Sunset, Meinecke, and Timbrel Grind and Inlay

ADDENDUM NO. 1

Addition/Change to the Contract Documents

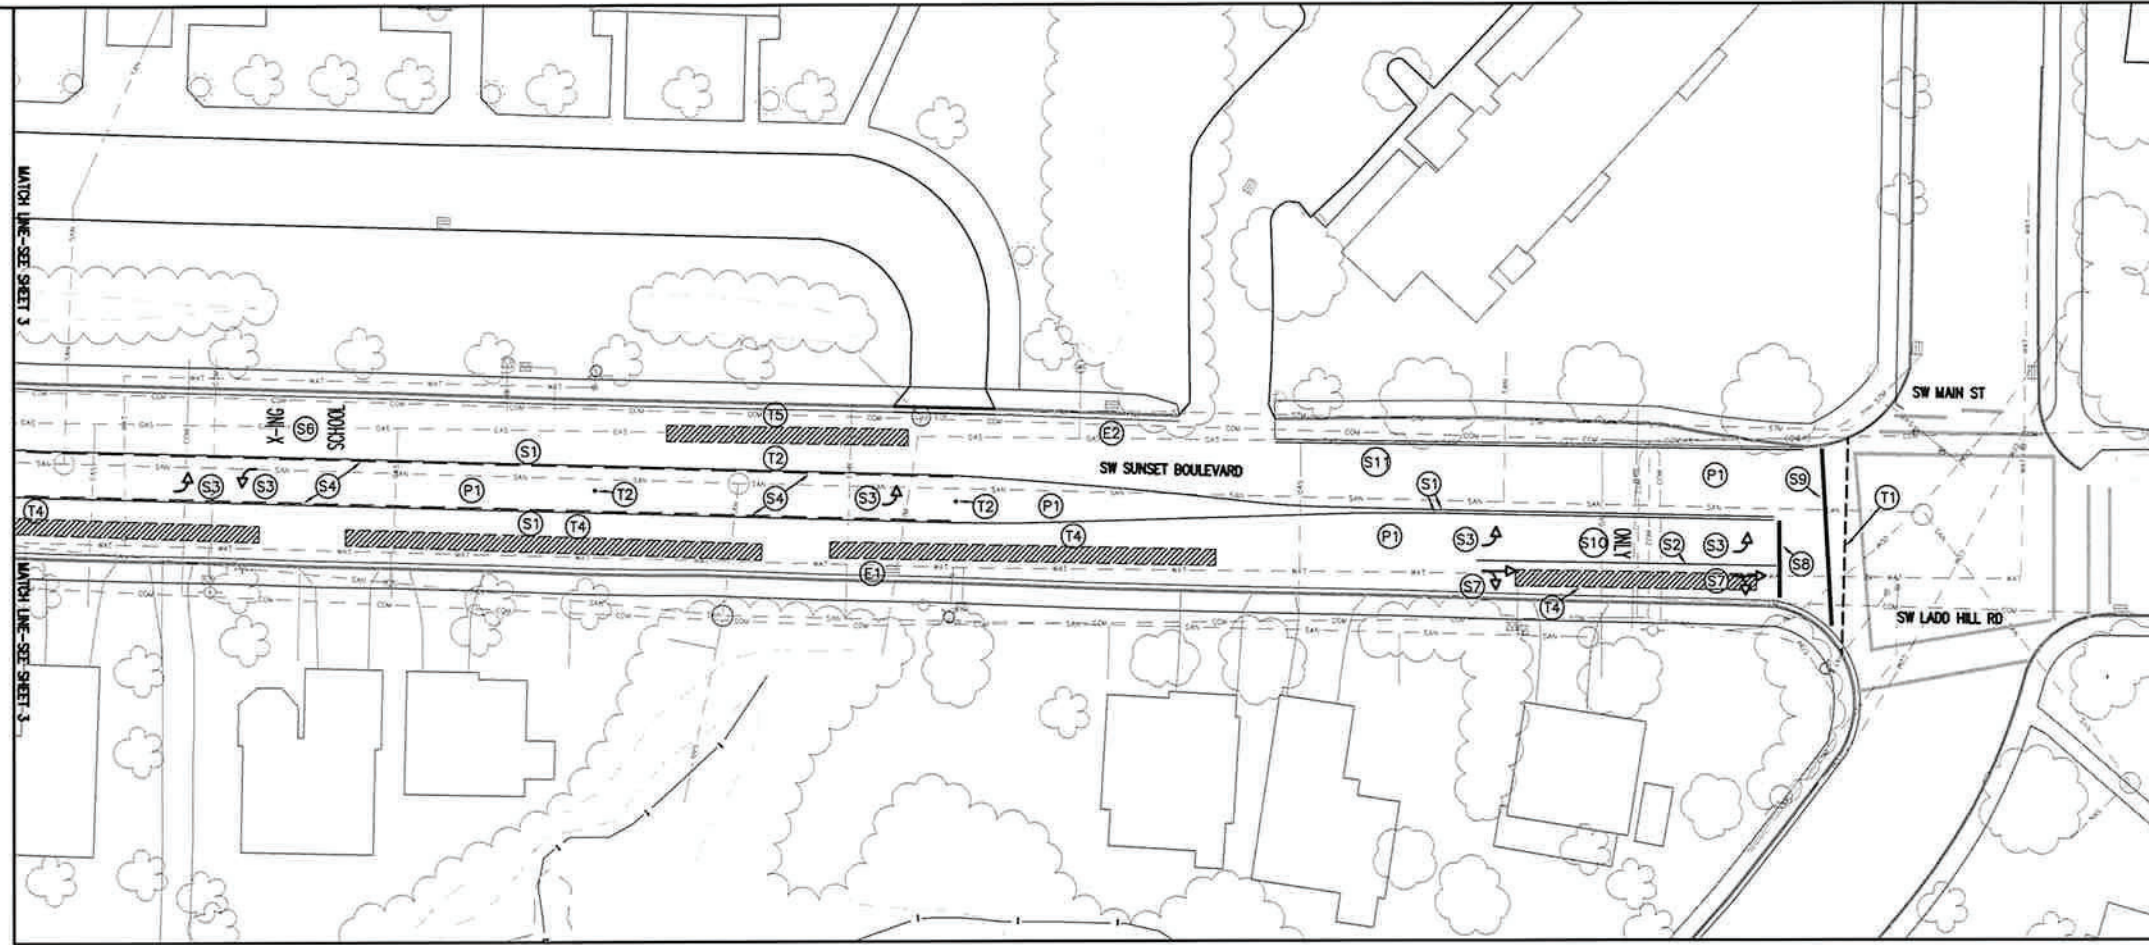
⚠ NOTE THAT FIBER MIX WILL NOT BE USED IN TRENCH REPAIR LIFTS OR ASPHALT REPLACEMENT ADJACENT TO SIDEWALK RAMPS (EXCLUDES FINAL OVERLAY)

**SW SUNSET BOULEVARD
(EAST PLAN VIEW)**

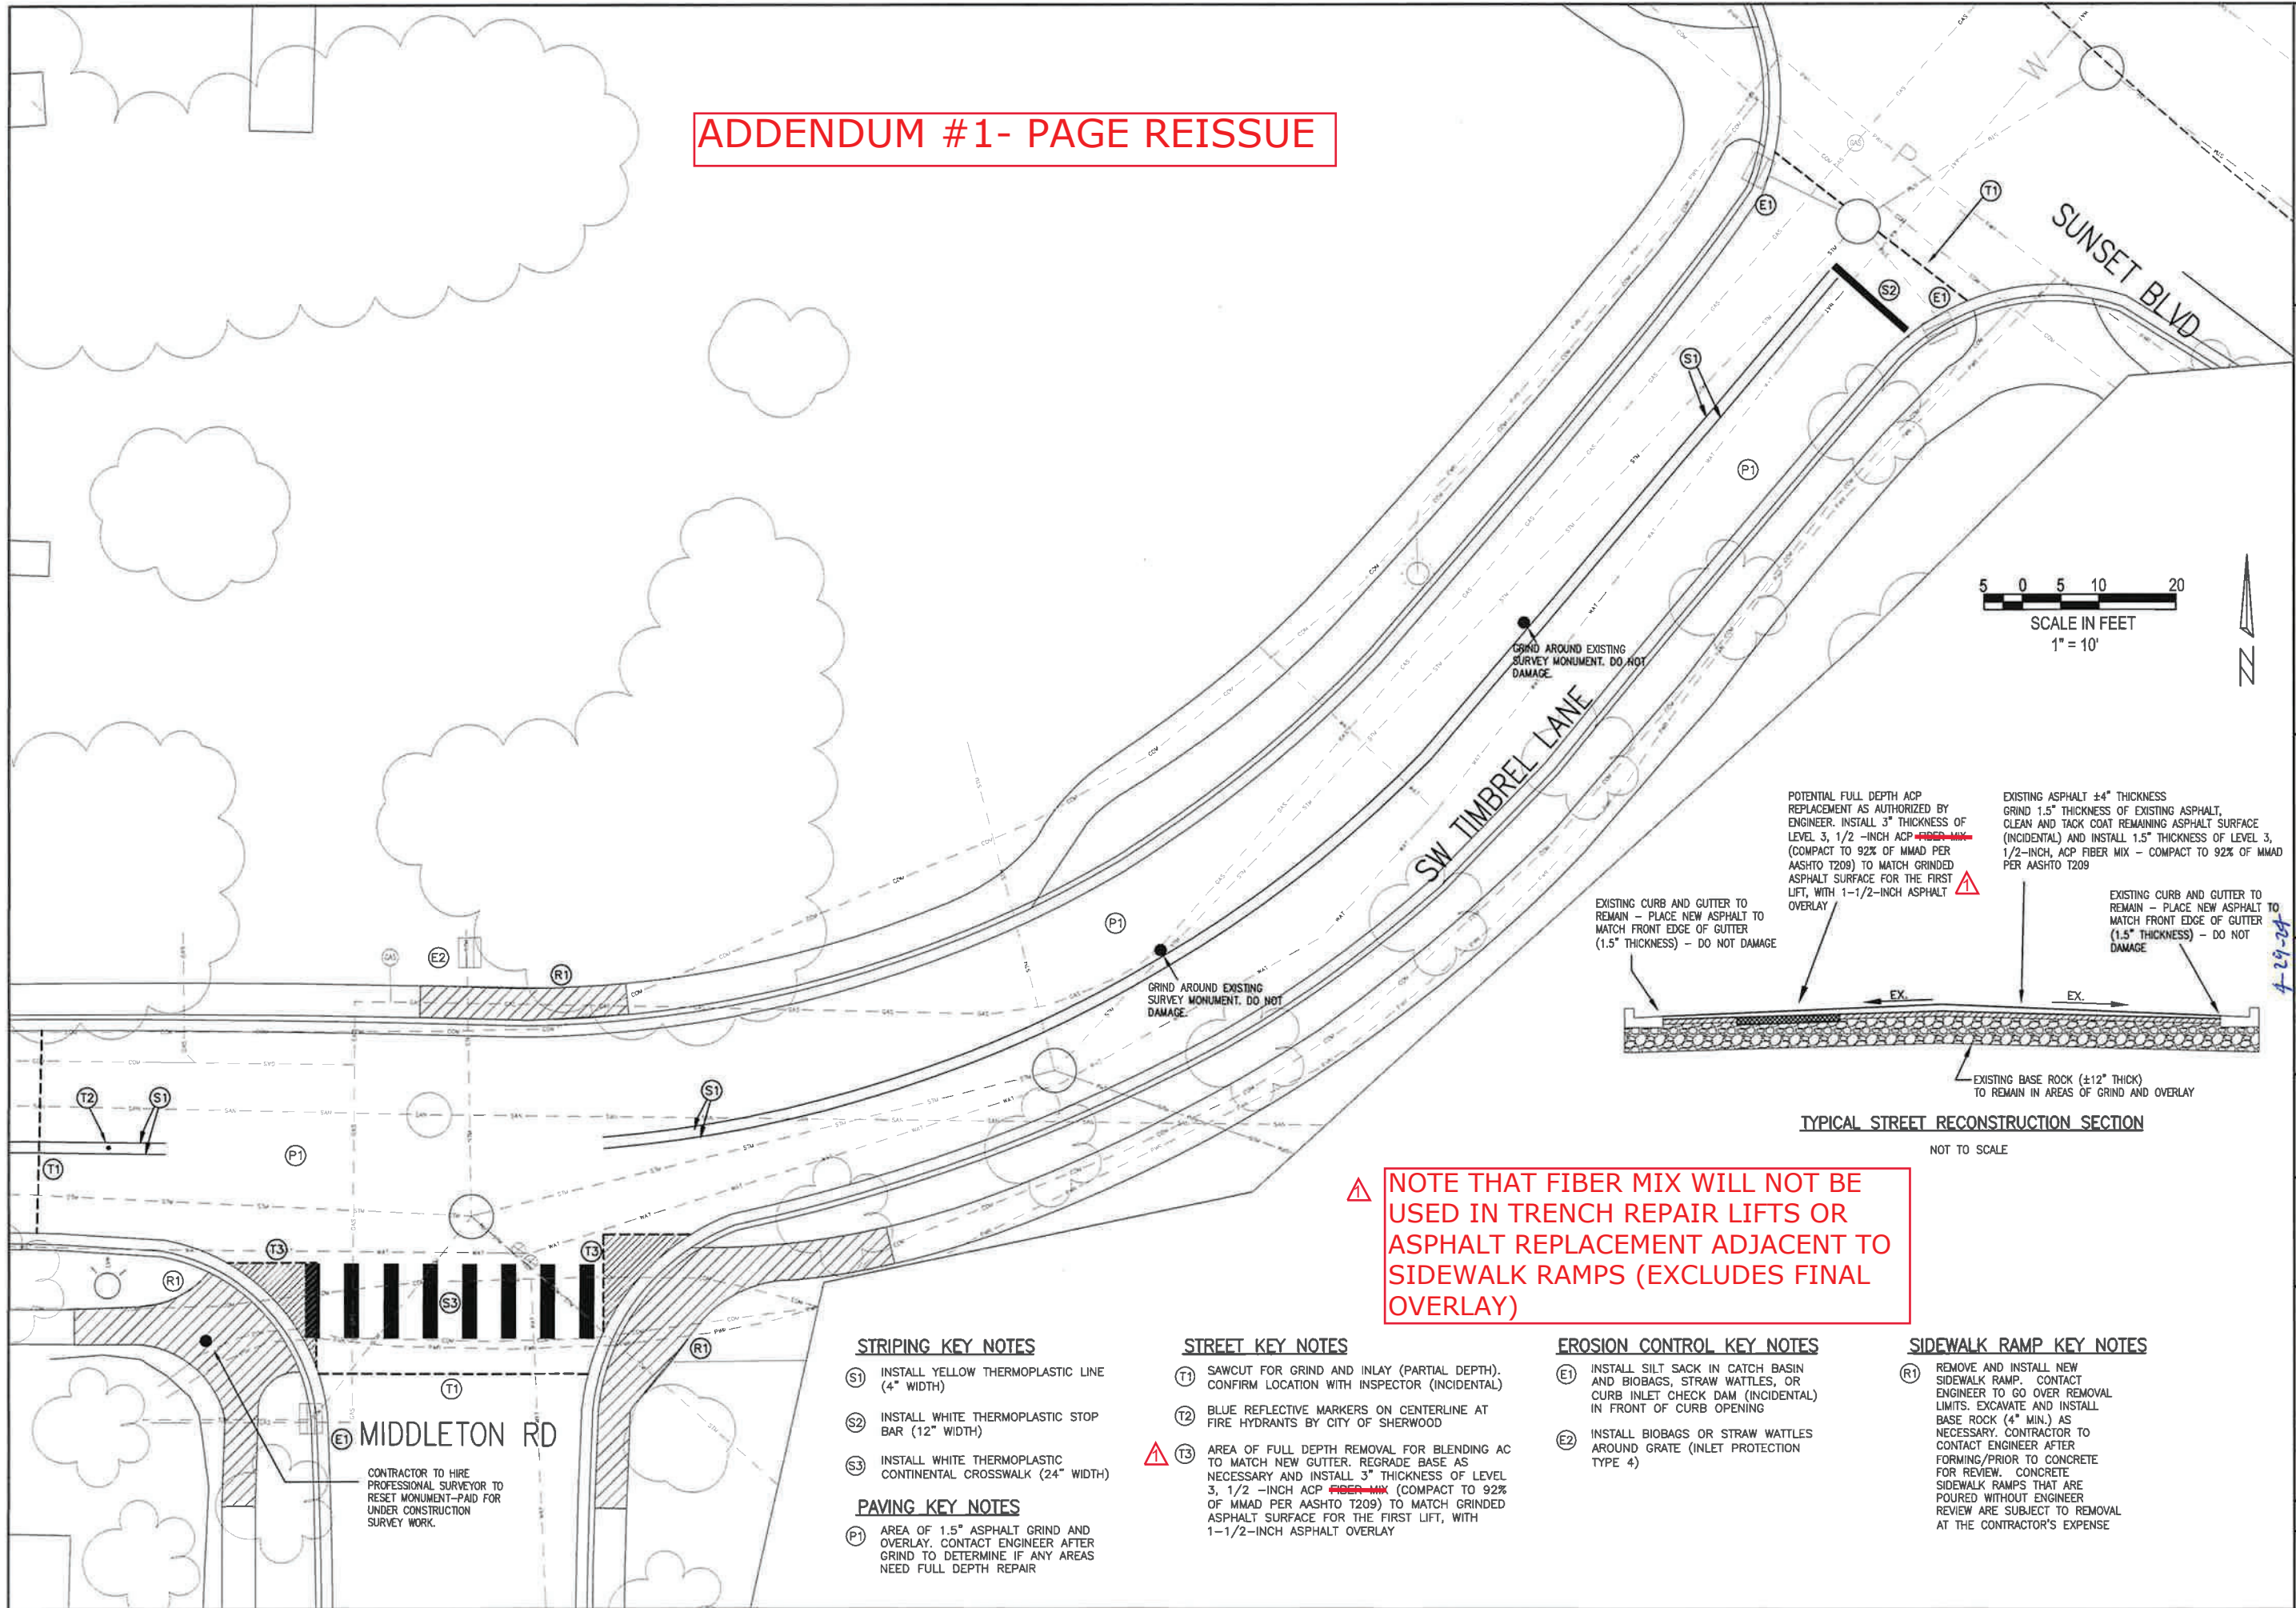
- (T3) CAUTION: EXISTING SHALLOW GAS LINE. TO BE REPLACED BY NW NATURAL. GRIND AND INLAY SHALL NOT BE INSTALLED UNTIL NW NATURAL HAS FINISHED TRENCH
- ⚠ (T4) AFTER GRINDING, AS DIRECTED BY ENGINEER, REMOVE REMAINING DEPTH OF ASPHALT TO BASE ROCK TO ALLOW FOR PLACEMENT OF 4" THICKNESS OF LEVEL 3, 1/2-INCH, ACP ~~FIBER MIX~~ IN 2 LIFTS (COMPACT TO 92% OF MMAD PER AASHTO T209) TO MATCH GRINDED ASPHALT SURFACE PRIOR TO 1-1/2" OVERLAY

- ⚠ (T5) AFTER GRINDING, AS DIRECTED BY ENGINEER, REMOVE REMAINING DEPTH OF ASPHALT TO BASE ROCK TO ALLOW FOR PLACEMENT OF 4" THICKNESS OF LEVEL 3, 1/2-INCH, ACP ~~FIBER MIX~~ IN 2 LIFTS (COMPACT TO 92% OF MMAD PER AASHTO T209) TO MATCH GRINDED ASPHALT SURFACE PRIOR TO 1-1/2" OVERLAY. THESE AREAS WILL LIKELY BE COMPLETED BY NW NATURAL AFTER SCHOOL IS OUT FOR SUMMER

- ⚠ (T6) AREA OF FULL DEPTH REMOVAL FOR BLENDING AC TO MATCH NEW GUTTER. REGRADE BASE AS NECESSARY AND INSTALL 3" THICKNESS OF LEVEL 3, 1/2" ACP ~~FIBER MIX~~ (COMPACT TO 92% OF MMAD PER AASHTO T209) TO MATCH GRINDED ASPHALT SURFACE FOR THE FIRST LIFT, WITH 1-1/2" ASPHALT OVERLAY. CONFIRM LIMITS WITH ENGINEER
